Summary of Expert Review Comments and Responses:
Draft Inventory of U.S. Greenhouse Gas Emissions and Sinks: 1990-2018

May 2020
U.S. Environmental Protection Agency
Office of Atmospheric Programs
Washington, D.C.

Responses to Comments Received during the Expert Review Period on the *Inventory of U.S. Greenhouse Gas Emissions and Sinks: 1990-2018*

Comment 27: 2018 manure distribution among waste management systems by operation

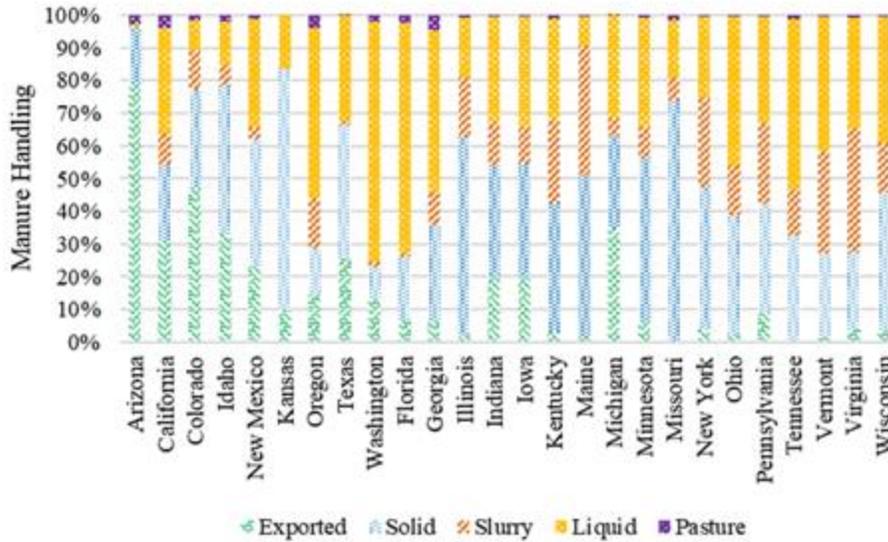
I am concerned about the accuracy of the values in Table A-188 on page A-41. The figure below was generated by a post-doc working in the ARS lab in Pennsylvania, based on the ARMS data. It is total mass of manure on dairies in different storage. To me, this distribution looks a lot more realistic for Idaho at least if I assume 100% of the manure exported was a solid. When I did my own “survey” I came up with about 76% of total manure stored as a solid. Discrepancies for other major dairy states are also present compared to this.

There also seems to be other manure data in ARMS so I am a bit perplexed by it. This would obviously have a very large impact on the values calculated and I think more work in this area could be done.

Response: EPA appreciates the commenter’s suggestions to improve the accuracy and clarity of the chapter describing GHG emissions from manure management (Chapter 5.2) and recognizes the commenter’s specific data recommendations to potentially improve emissions estimates. EPA is regularly reviewing literature and available data sources for updated activity data including methane producing potential, volatile solids and nitrogen excretion rates, waste management system usage data, methane conversion factors, and emission factors. Note that volatile solids and nitrogen excretion rates for cattle are reliant on underlying data provided in Chapter 5.1 (Enteric Fermentation), which EPA acknowledges is also an area for potential improvements. EPA appreciates the commenter for confirming known available data and applicable references; EPA will review these items as resources allow. EPA is aware of IPCC’s 2019 Refinement to 2006 IPCC Guidelines for National Greenhouse Gas Inventories and plans to review updated methodologies and emission factors as resources allow, as noted in the Planned Improvements section of Chapter 5.2.
